## **Product Change Notice (PCN)**

PCN Number: PCN-0456175R

Product(s) Affected: PJ-082BH

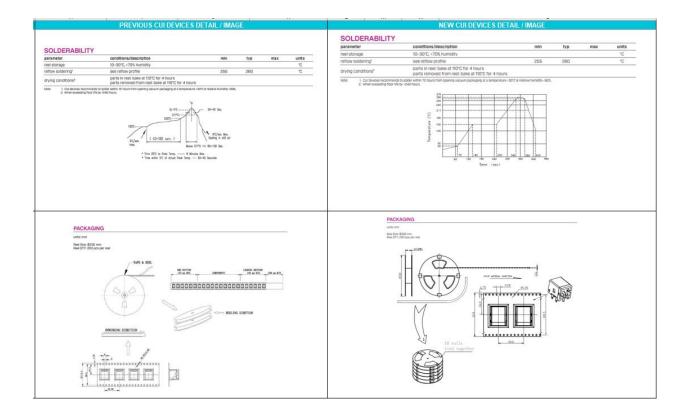
Description of Change: New Factory Location. Product re-engineered for improved manufacturability and production yield. See image below for reference and check CUI Devices website for updated drawing. Cosmetic differences may be visible and not affect the form fit and function of the product.

PREVIOUS CUI DEVICES DETAIL / IMAGE			NEW CUI DEVICES DETAIL / IMAGE		
			DESCRIPTION	MATERIAL	PLATING/COLOR
DESCRIPTION	MATERIAL	PLATING/COLOR	center pin	zinc alloy	nickel
terminal 1	brass	silver	terminal 1	zinc alloy	nickel
terminal 2	copper t=0.30	silver	terminal 2	C5191 t=0.30	silver
stopper	SUS 301 t=0.30		stopper	C2680 t=0.40	
shield A	SPCC t=0.40	nickel	shield A	SPCC t=0.30	nickel
shield B	SUS 301 t=0.15		shield B	SUS 301 t=0.10	
housing	PA9T (UL94V-0)	black	housing	PA9T (UL94V-0)	black
